BID ADDENDUM

Addendum No.: 2
Date: November 12, 2025
Project: Swan Meadows Water and Sewer Improvements Project
KCI Project No. 00011474_00001

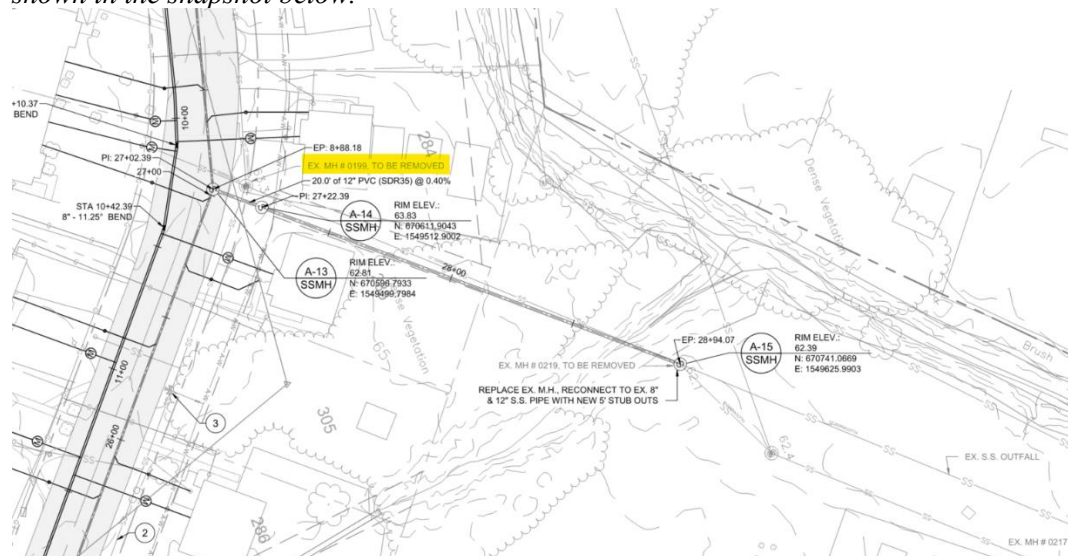
1. **Question:** Drawing Sheet C-1.01. Under Phase 1, sewer, note #2 requires bypass pumping from the existing manhole MH-0199 to MH-0217. Please clarify where manhole MH-0199 is shown on the drawings.

Answer: MH-0199 is identified on Sheet C-1.05. The callout to the existing MH #0199 is shown in the snapshot below.
